## **MAKING A CASE FOR A VARIATION OF THE HOUSE DESIGN SUBMITTED IN THE ORIGINAL PLANNING APPLICATION.**

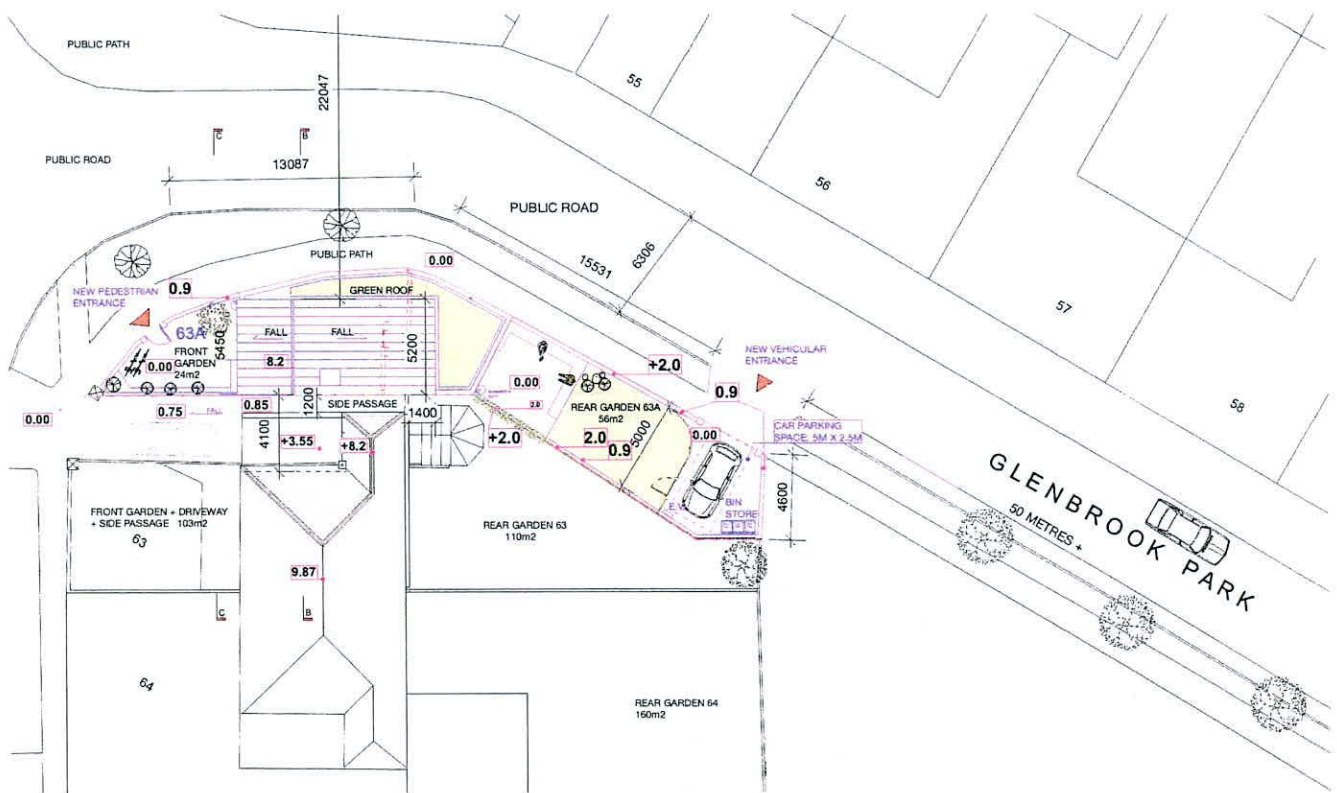
- 1 The provision of a car parking space to the rear of the property.
2. The 'pulling forward' of the first floor level of the proposed house so that it aligns with the front building line of No. 63 ( and the line of houses along that part of the street).This reduces the depth of the projection of the rear building line of the proposed house at first floor level beyond the rear building line of No. 63.
3. The height of the boundary walls to the front garden and to the rear car parking area are reduced in height to 0.9 m
4. The width of the rear garden to the proposed house, 63A is increased .

Site layout image with car parking space shown to the rear of the property ( N.T.S)

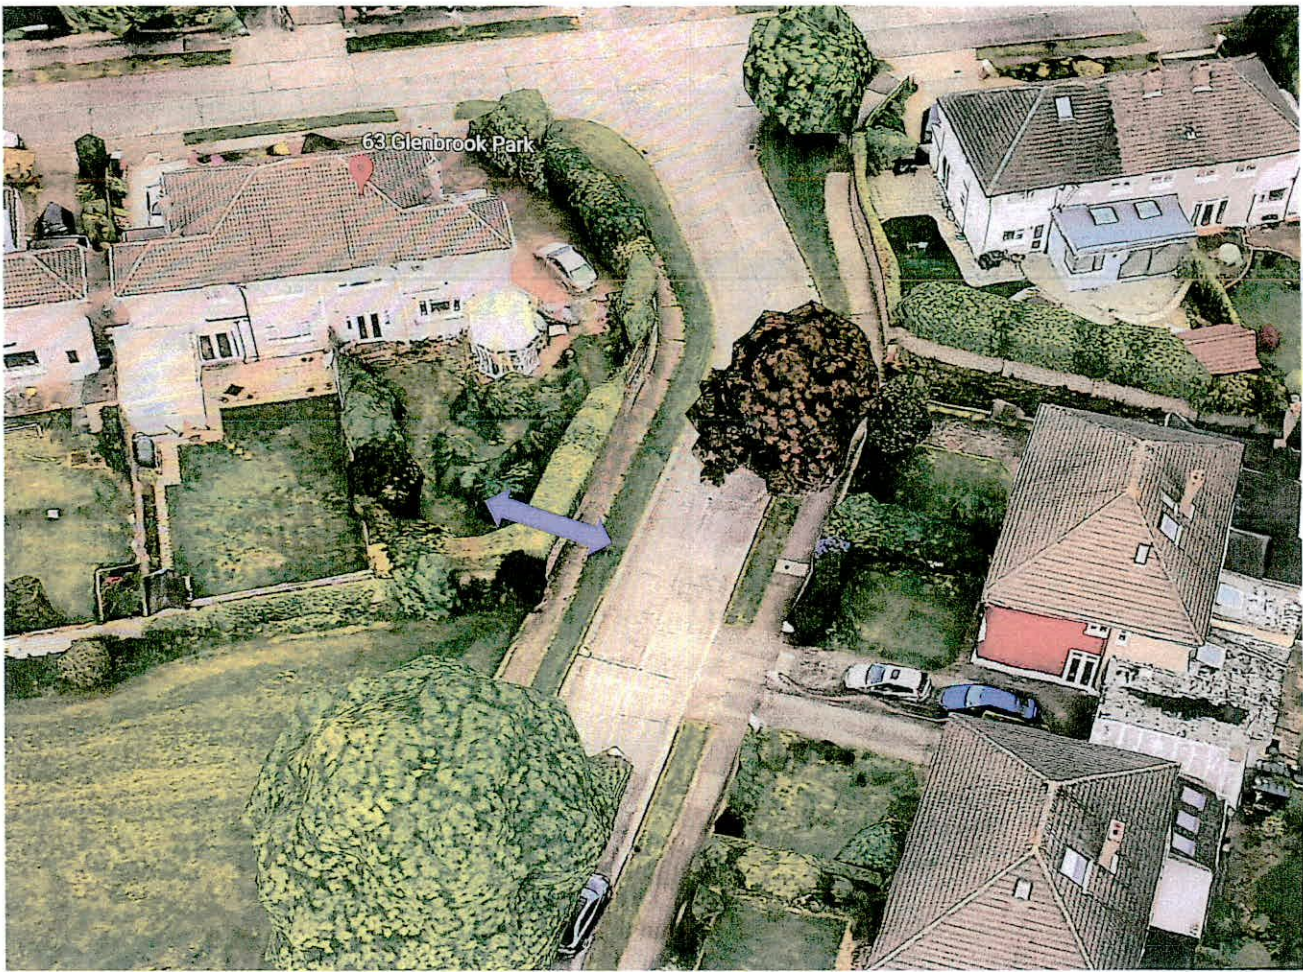
In this Variation of the House design an on-site car parking space, measuring 5M x 2.5M is provided to the rear of the property in a proposed car parking and bin storage area. A new vehicular entrance of width 3.2M to be created to access the car parking space.

The car parking space will be positioned perpendicular to the carriageway and accessed through a 3.2m wide vehicular entrance. This 'driveway ' will allow a car drive in frontways and reverse out as for most of the houses in this residential estate. The location, as indicated on the aerial view image below has good sightlines and would allow the safe access/egress of a car from the parking space. The boundary walls are replaced with boundary walls of lower height to allow a clear views up and down the street whilst entering and exiting the space.
